GROUND FLOOR PLAN

CLIENT	: JSSM
PROJECT	: 1 FE SCHOOL
SITE	: 261 HALE LANE EDGWARE MIDDX
DRAWING	: GROUND FLOOR PLAN
DATE	: 05.08
DRAWN BY	: PM
SCALE	: 1:200
JOB + DRAWING No:	HL.673.01 <sup>B</sup>

CLIENT : JSSM  
 PROJECT : 1 FE SCHOOL  
 SITE : 261 HALE LANE  
 EDGWARE MIDDX  
 DRAWING : FIRST FLOOR PLAN

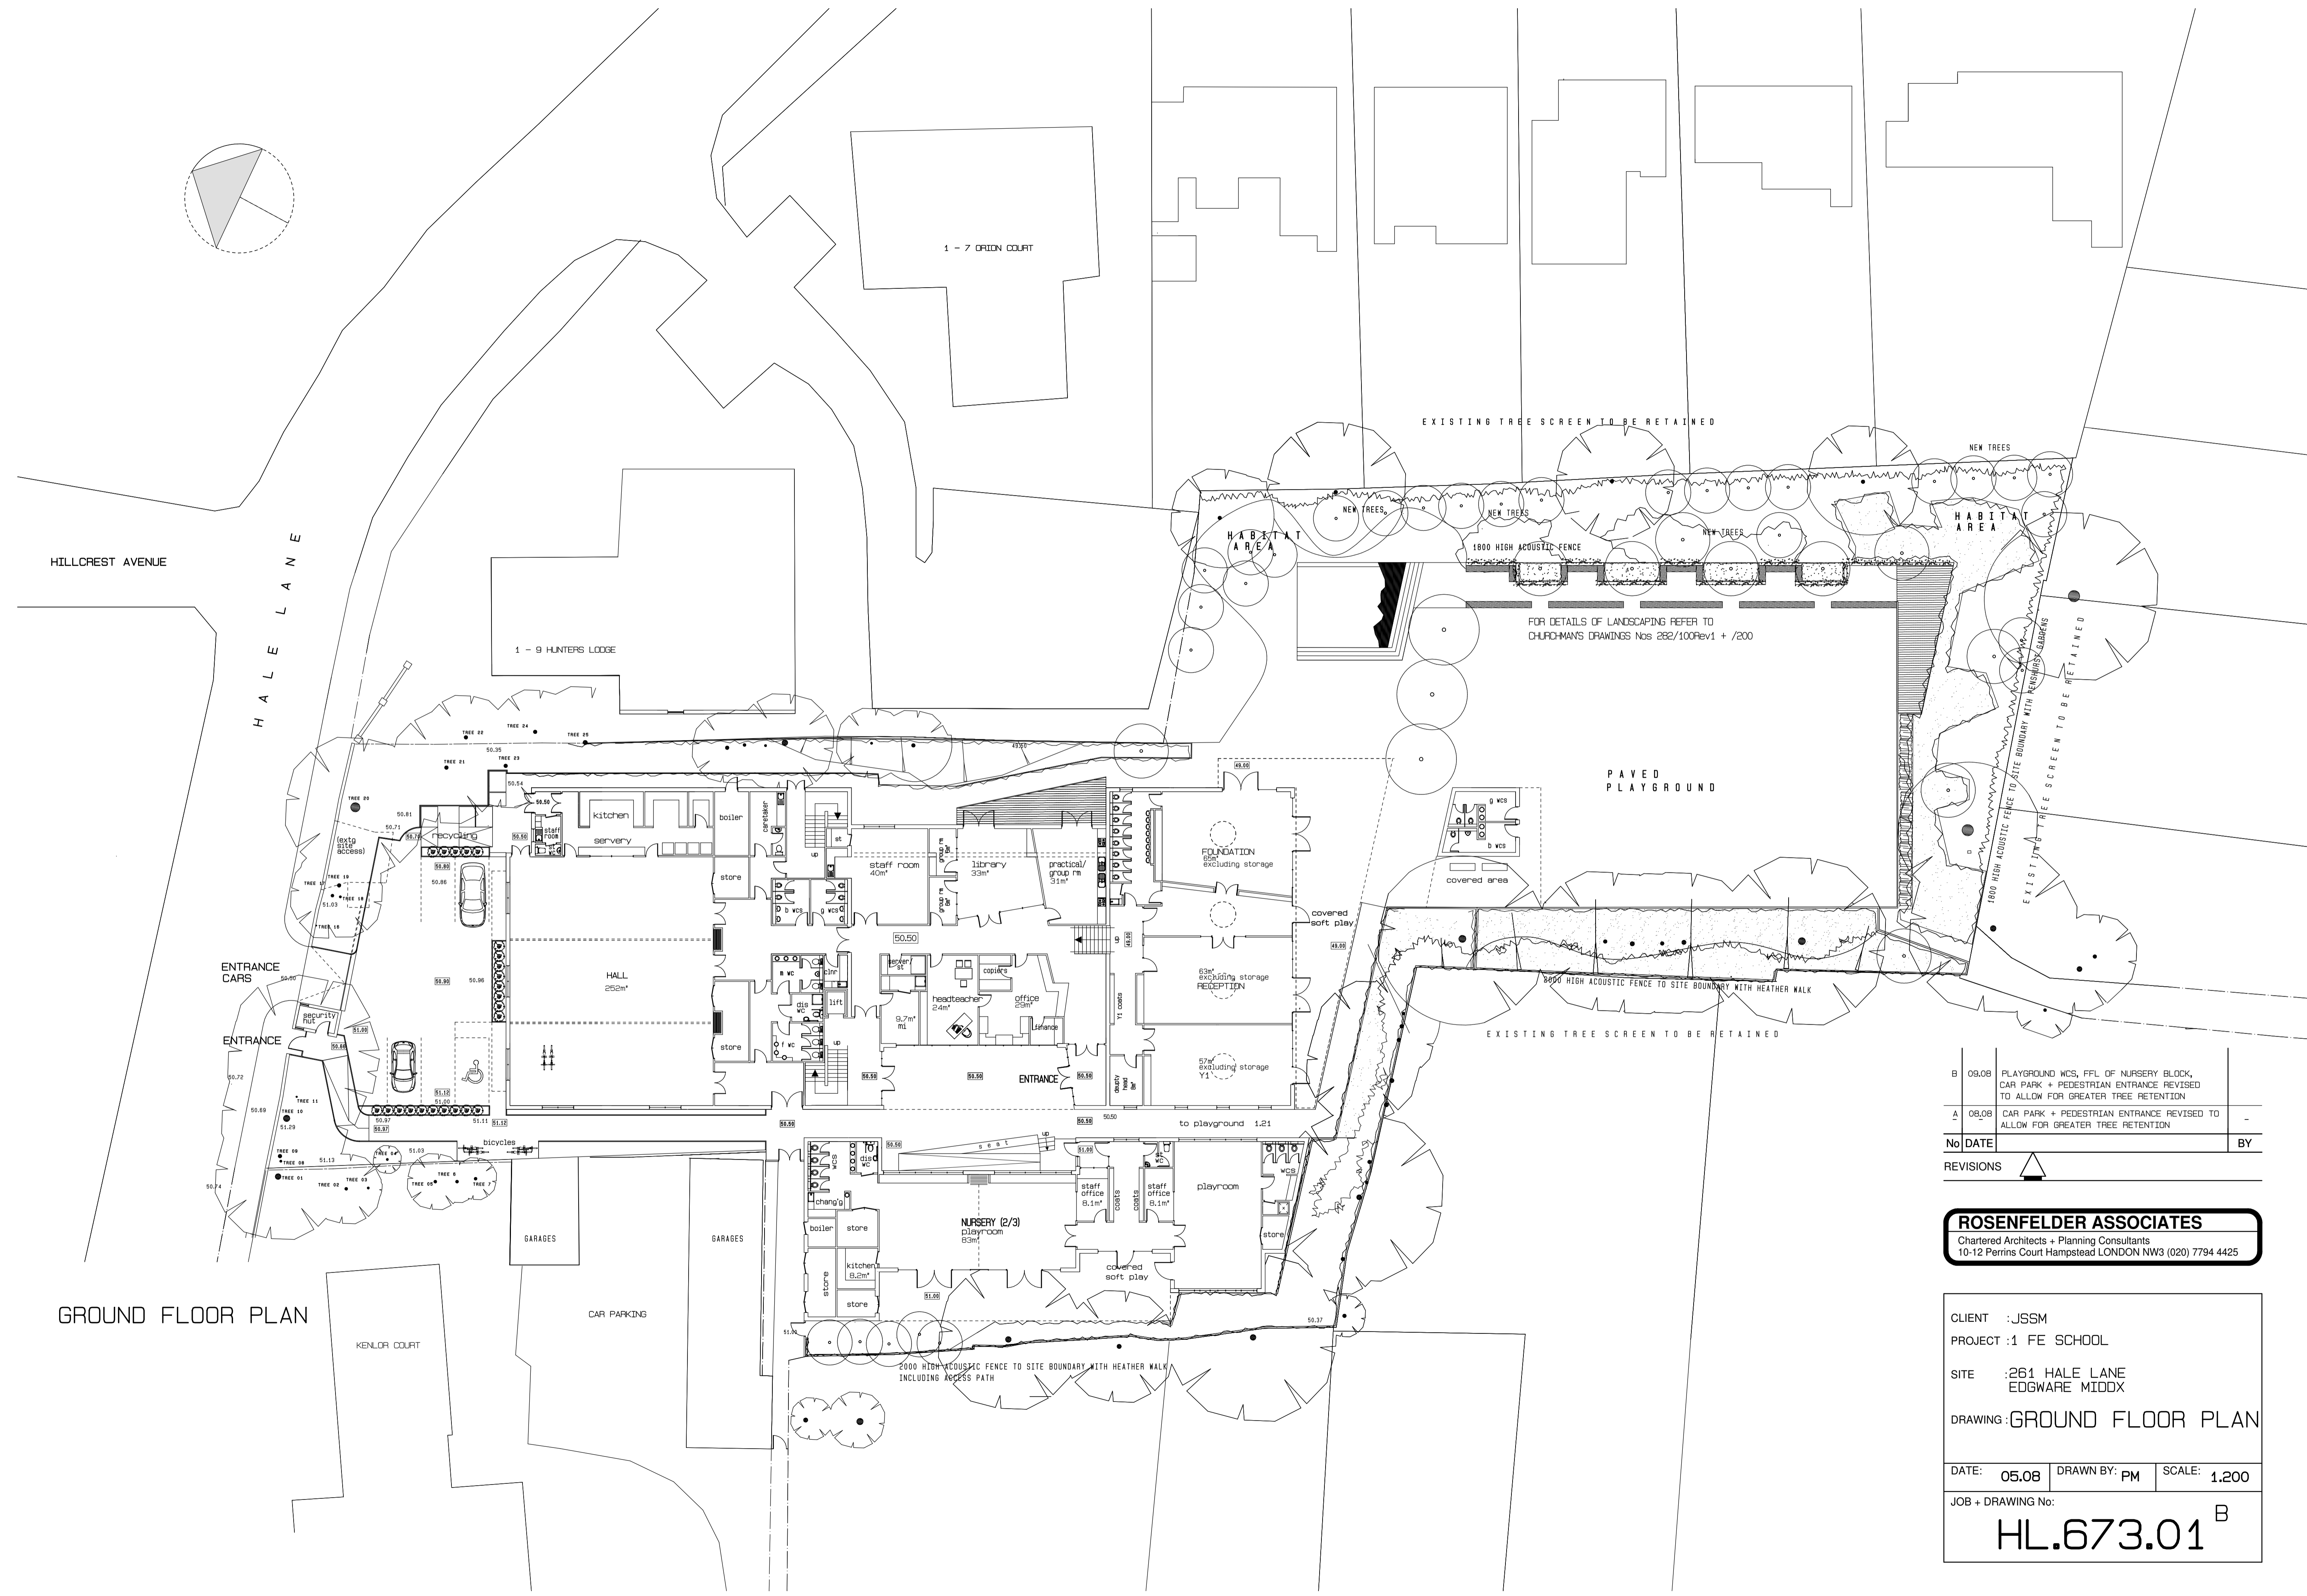
B	09.08	PLAYGROUND WCS, FFL OF NURSERY BLOCK, CAR PARK + PEDESTRIAN ENTRANCE REVISED TO ALLOW FOR GREATER TREE RETENTION	
A	08.08	CAR PARK + PEDESTRIAN ENTRANCE REVISED TO ALLOW FOR GREATER TREE RETENTION	
No	DATE		BY
REVISIONS
